Parallel Trail

(Mid-Coast Multi-Modal Trail)

60% Plan submittal update

MID-COAST COMMUNITY COUNCIL

Original Retaining Wall Cross Section

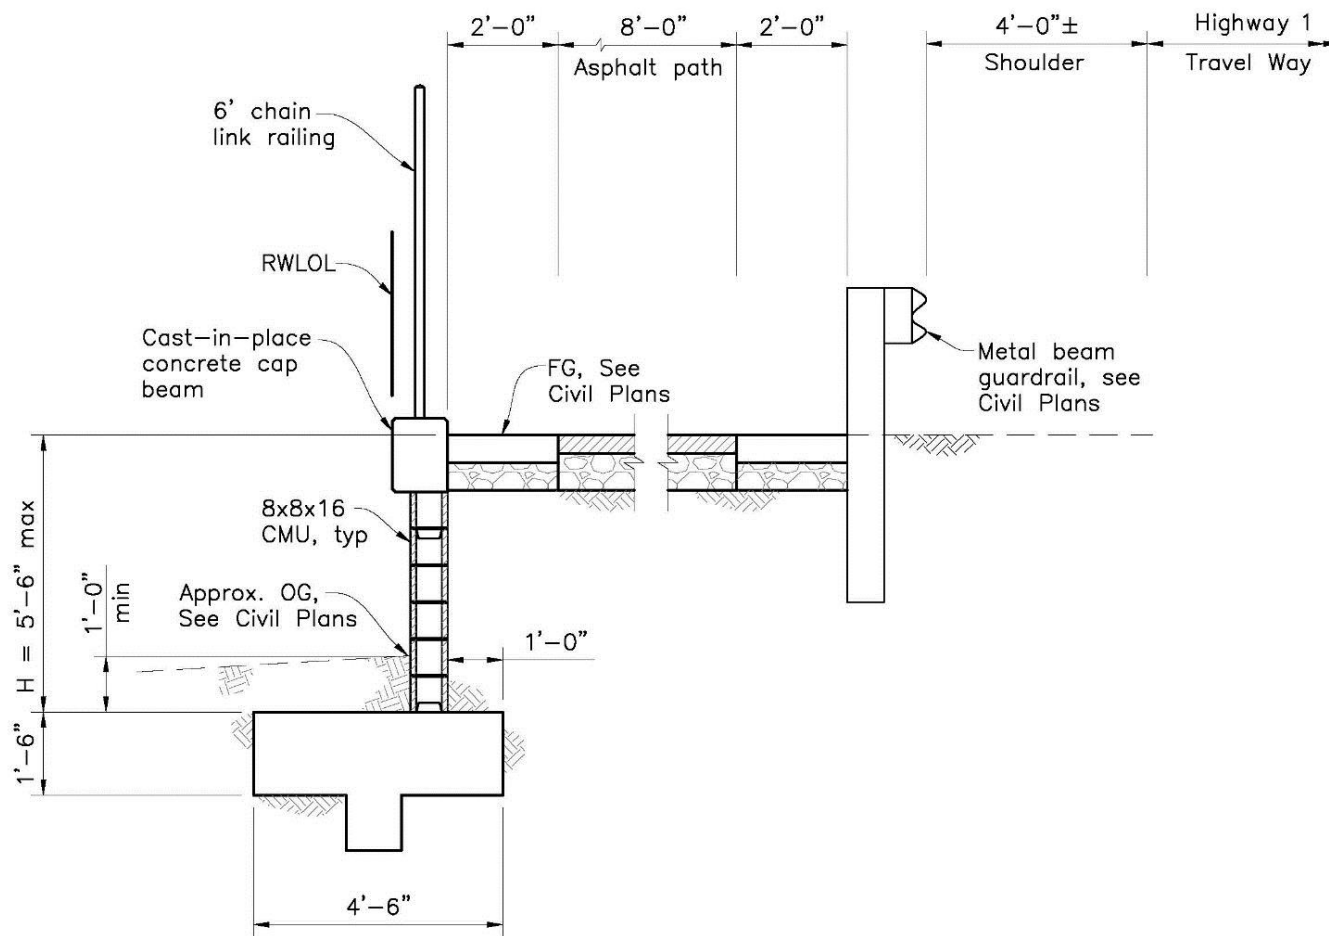
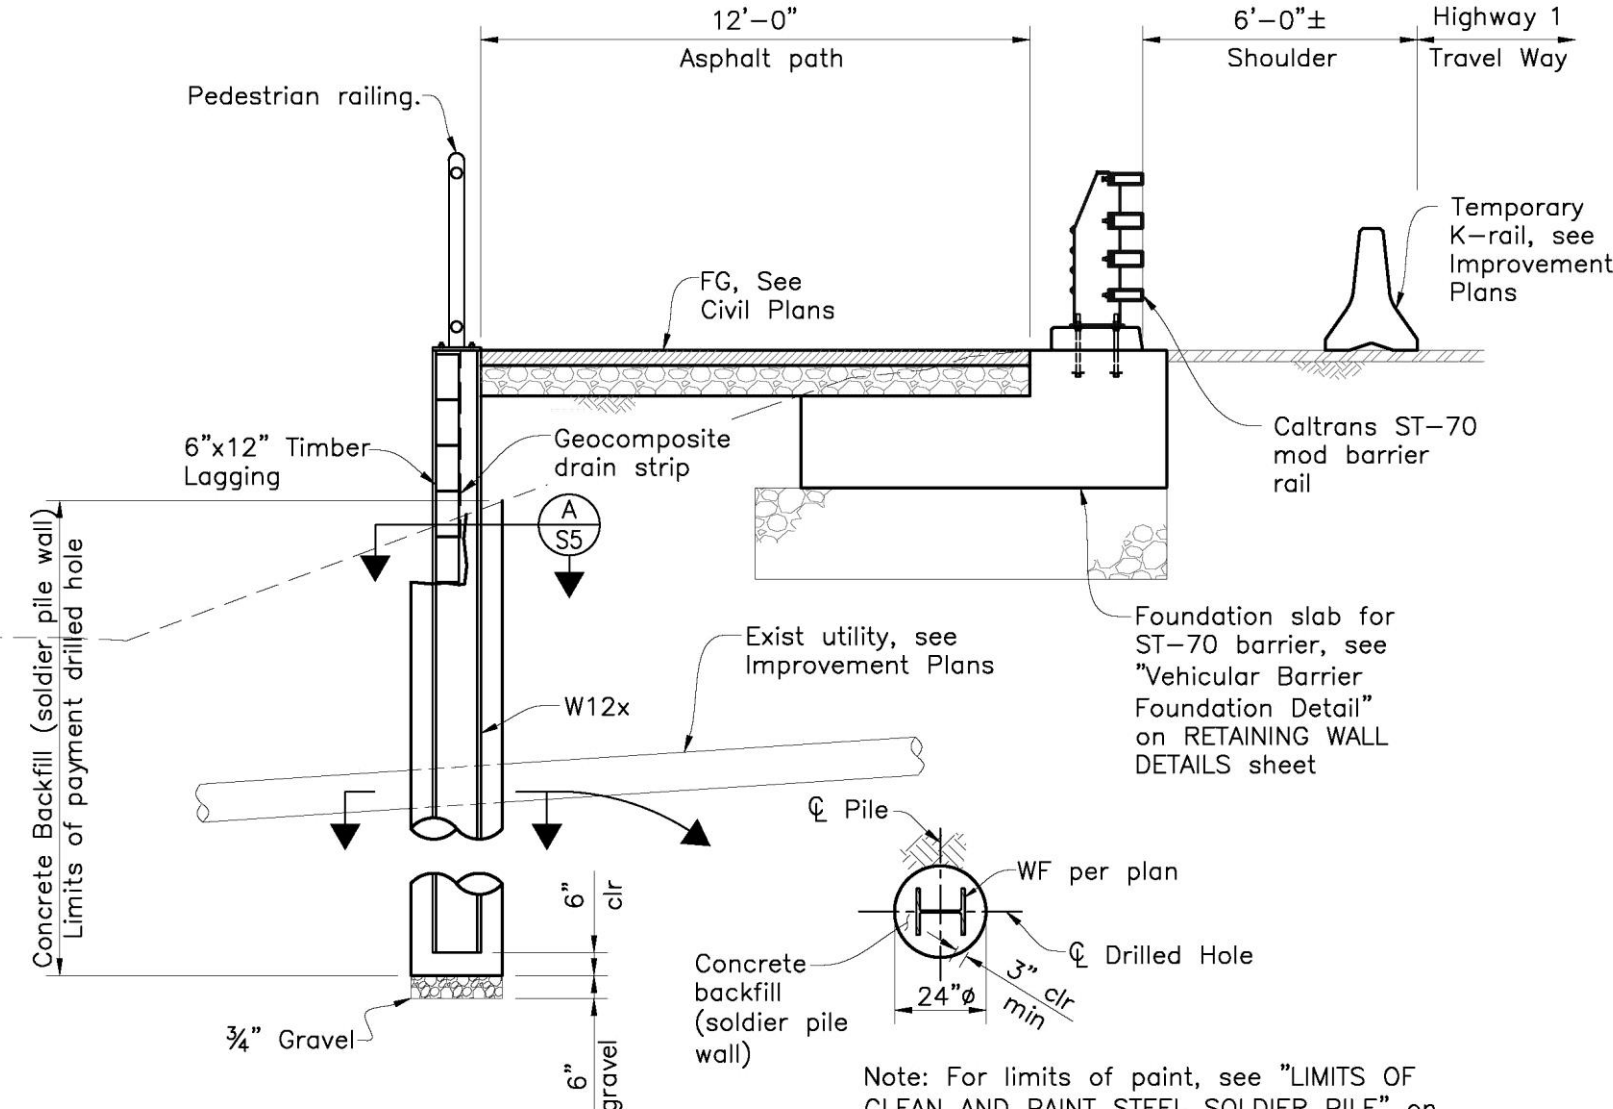
Revised Retaining Wall Cross Section

Note: For limits of paint, see "LIMITS OF CLEAN AND PAINT STEEL SOLDIER PILE" on RETAINING WALL DETAILS sheet.

Original Pedestrian Bridge Design

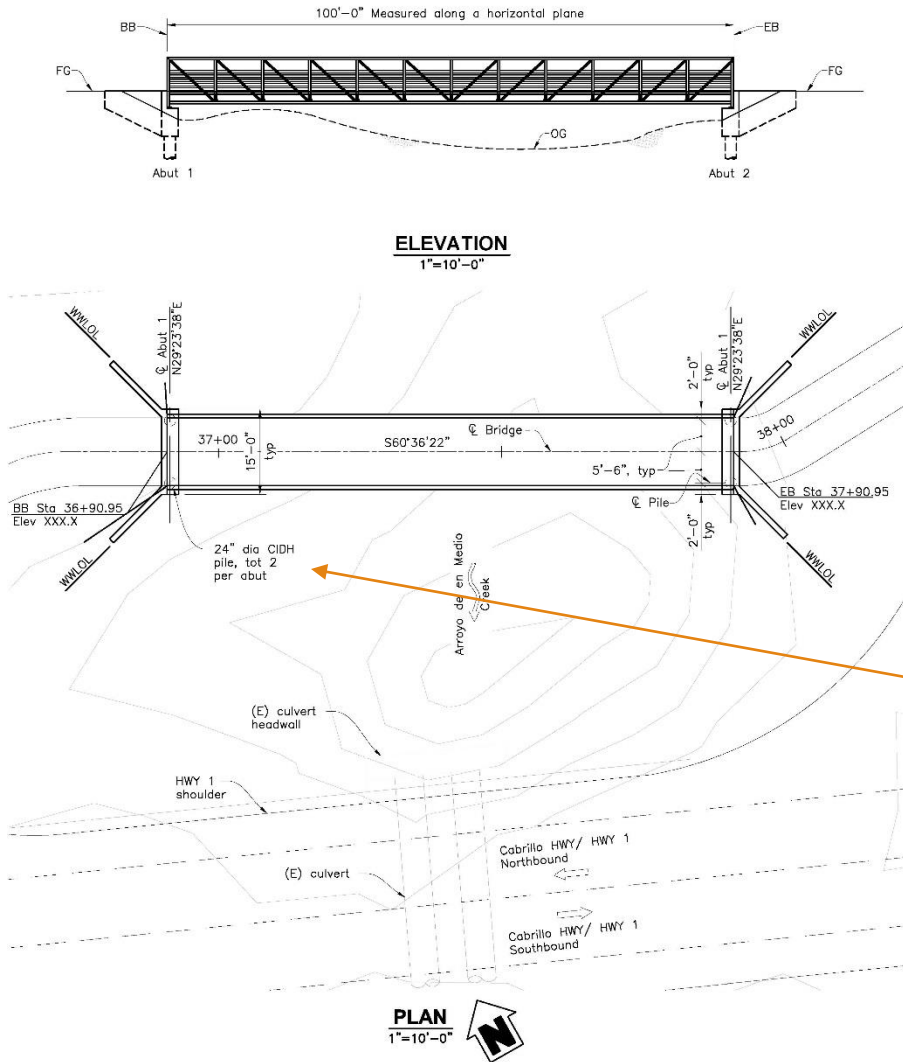
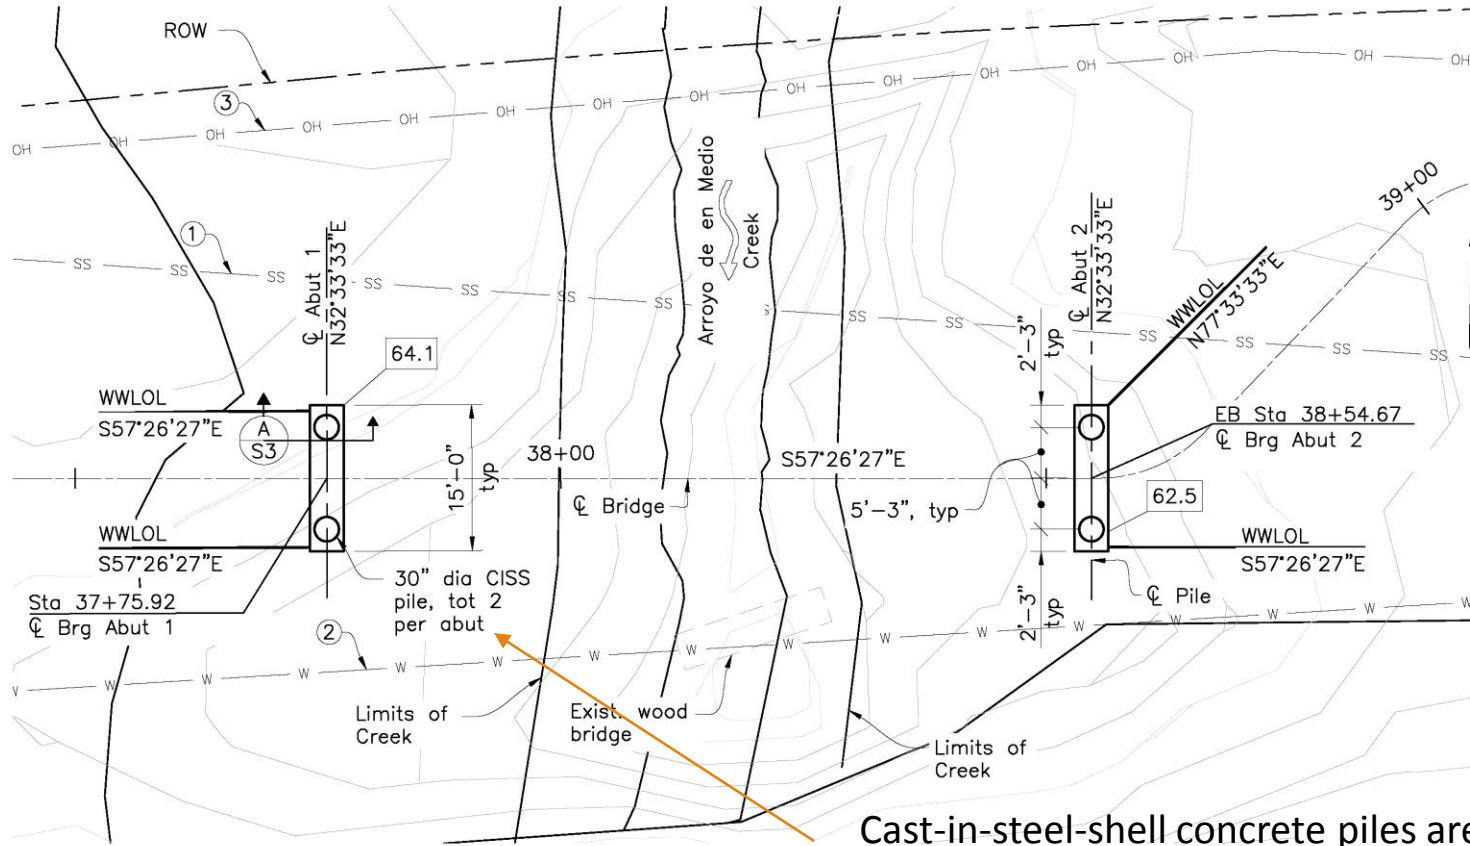
Cast-in-drilled-hole piles (CIDH piles) - a borehole is drilled into the ground, then concrete (and often some sort of reinforcing) is placed into the borehole to form the pile

Revised Pedestrian Bridge Design

Cast-in-steel-shell concrete piles are driven pipe piles that are filled with cast-in-place reinforced concrete no deeper than the shell tip elevation.
